Service bulletin

GEARBOX MOUNTING

AUSTIN
HEALEY
SPRITE
MK. III

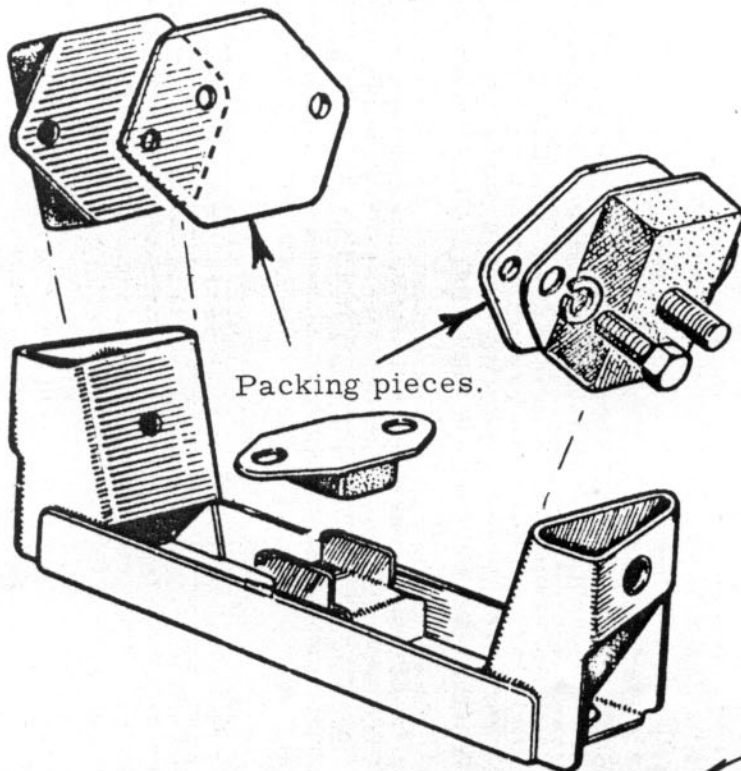
Certain complaints of engine vibration and harshness have been traced to the gearbox rear extension resting on the rear mounting support.

This condition may be rectified by inserting packing pieces, Part No. 2A 5423, between the mounting assembly and the gearbox rear extension, as incorporated in production from the following change-point:

Austin Healey Sprite Mk. III Car No. 48403.
